These errata apply **ONLY** to Spartan-3 XC3S200 FPGAs, including both production devices and engineering samples. These errata **DO NOT** apply to any other Spartan-3 FPGA. If using a different Spartan-3 FPGA, check for errata specific to that device.

Table 1: Spartan-3 XC3S200 FPGAs Affected by This Errata

Hardware Errata Summary

Figure 3: Requirements when VCCINT is not the Last Supply

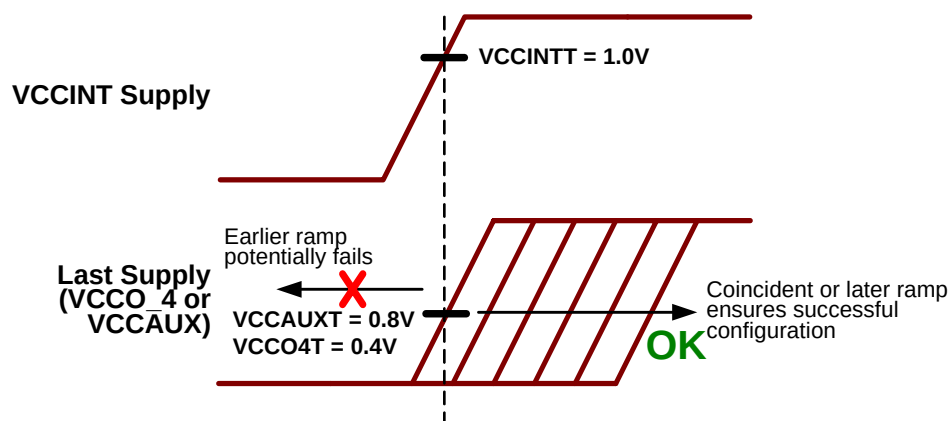
In the potentially failing condition, the VCCINT supply must be the last supply to reach its valid POR voltage and the ramp rate must be slower than 500 μ S. When the FPGA fails to configure, the INIT_B remains Low and the FPGA ignores the PROG_B program pin. Even with the worst identified power sequence, actual failures only occur on a small percentage of devices, typically measured in parts per million. The issue is more pronounced at cold temperatures.

OPTION 2: Use a power-on sequence where VCCINT is not the last supply to reach its POR threshold level.

VCCINT must reach its maximum POR threshold ($V_{CCINTT} = 1.0V$) before or coincident with VCCAUX reaching its minimum threshold ($V_{CCAUXT} = 0.8V$). This supply sequence and threshold relationship is illustrated in [Figure 3](#).

Alternatively, VCCINT must reach its maximum POR threshold ($V_{CCINTT} = 1.0V$) before or coincident with VCCO_4 supplying I/O bank 4 reaching its minimum threshold ($V_{CCO4T} = 0.4V$). This supply sequence and threshold relationship is also illustrated in [Figure 3](#).

The lowest power-consuming sequence is to apply VCCAUX before or coincident with VCCINT, then VCCINT followed by VCCO_4. If VCCINT is applied before VCCAUX, the VCCINT supply consumes a surplus current until the VCCAUX supply reaches its maximum POR threshold, VCCAUXT. This additional current is a few hundred to several hundred milliamps (mA). This additional current is not required for successful configuration and the surplus current disappears when VCCAUX is applied.

Figure 5: Enable User Editing in FPGA Editor

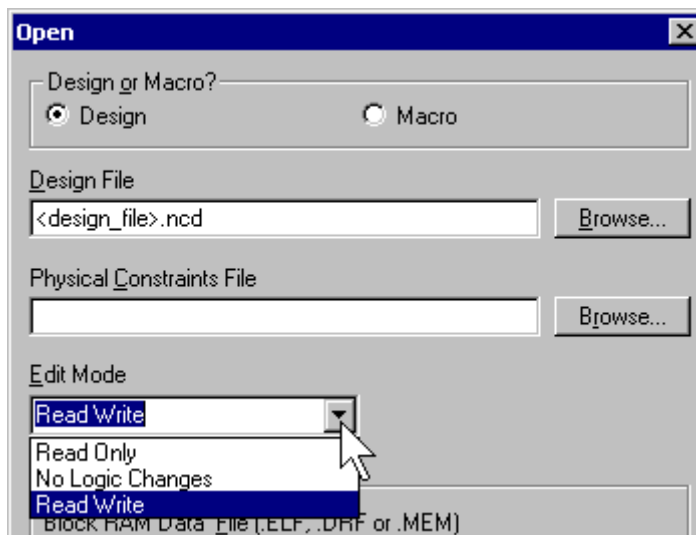
The DCM automatically compensates for process, voltage, and temperature (PVT) changes and consequently it periodically updates its delay tap settings. The rate at which the update occurs is controlled by an internal attribute called FACTORY_JF. Xilinx has identified an optimal FACTORY_JF setting value (FACTORY_JF=8080). Other settings may potentially fail to track properly over process, voltage, and temperature.

Without using the optimal settings, the DCM could potentially, with low probability, fail to assert the LOCKED output, could lose lock, or could produce erroneous clock outputs.

The new optimal settings are applied starting with Xilinx ISE 8.2i. If using an earlier version, modify the new FACTORY_JF=8080 settings on each DCM instantiated in the design. [Table 10](#) shows the best available options to update the DCM settings, depending on current design status.

- Invoke the FPGA Editor. On Windows PCs, select **Start → Xilinx ISE 6 → Accessories → FPGA Editor**.
- Select **File → Open**. Select the *.ncd file for the completed design. Set the **Edit Mode** to "Read Write" mode as shown in [Figure 5](#).
